JINDAL ALUMINIUM LTD.
BANGALORE-560073 (INDIA)

NAME	DATE
DRAWN	J.P.KAUSHIK	19-09-2019
CHECKED		
APPROVED	B.NATARAJA	25-09-2019
SCALE		2:1
AREA	mm ²	432.962
PERIMETER	mm.	221.52
WEIGHT	kg/m	1.169
DRAWING No.	SECTION No.	
P-11315-1	-	
29455	29455(ISSUE-2)

PARTY'S NAME	MODTEC INDUSTRIES LTD., NEW ZEALAND
PARTY'S DRAWING No.	PART No:-SAM0837 REV. 1
ALLOY & TEMPER	6063 T6
DESCRIPTION	BLADE RUNNER SLIDE SECTION

P-11315-1

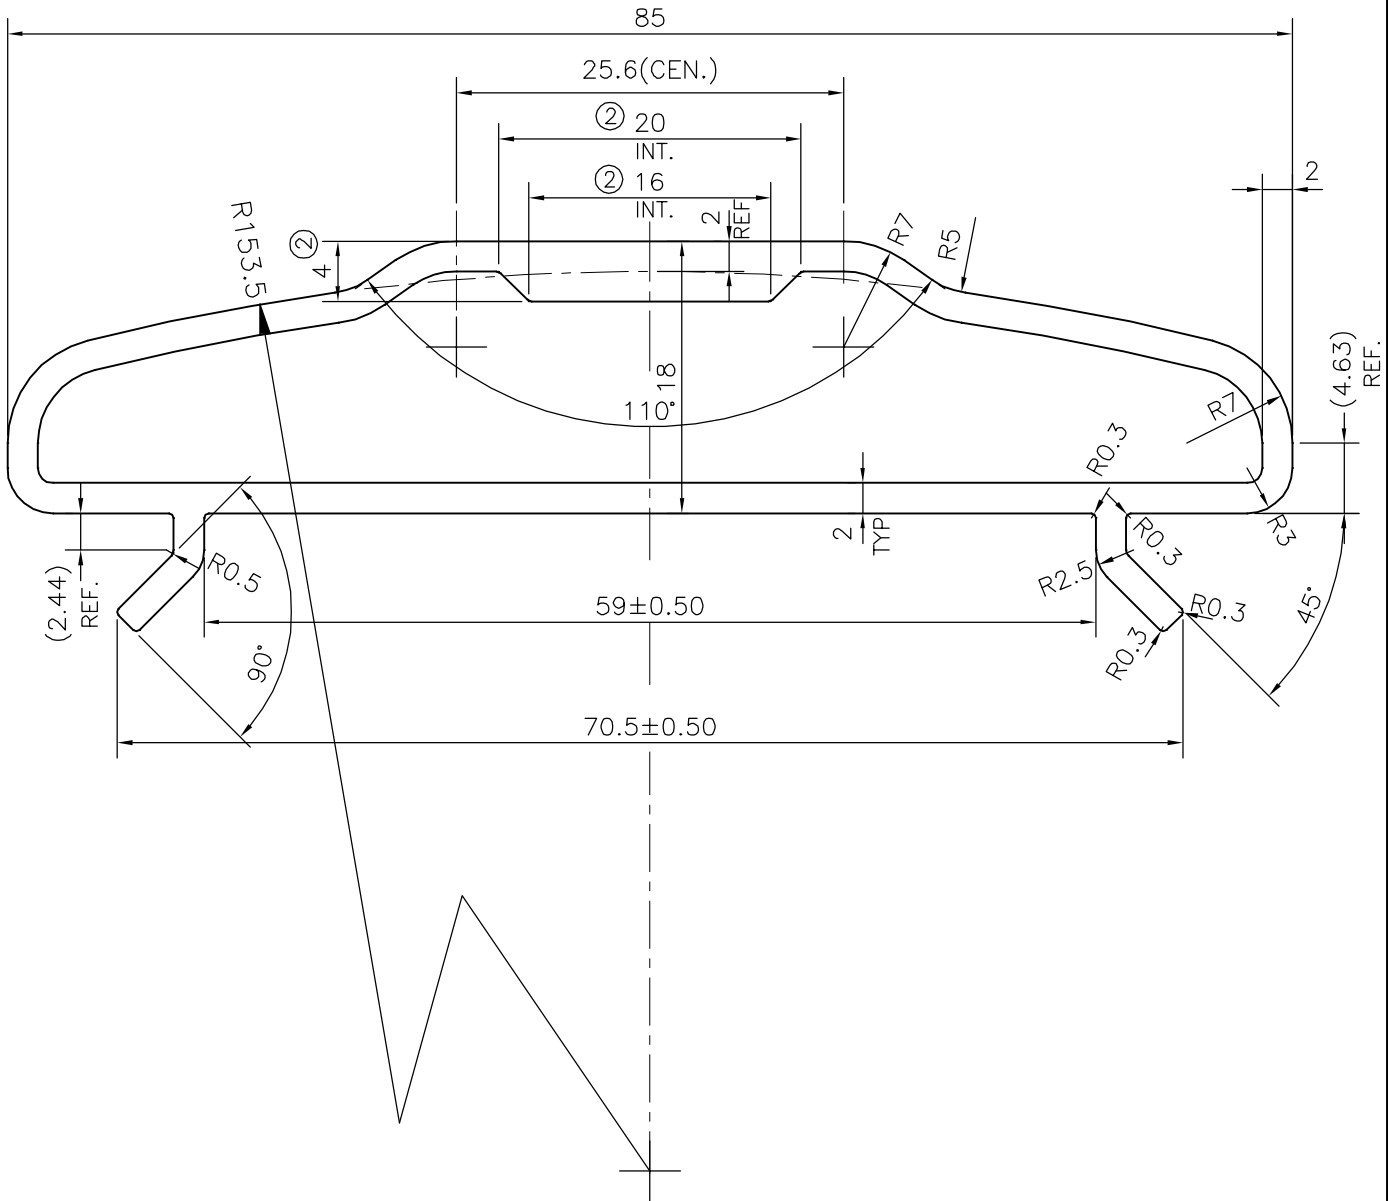
ISSUE-2

SHAPE CHANGED & DIMENSIONS ADDED 20 mm, 16 mm & 4 mm

WEIGHT ALSO CHANGED FROM 1.072 TO 1.169 kg/m
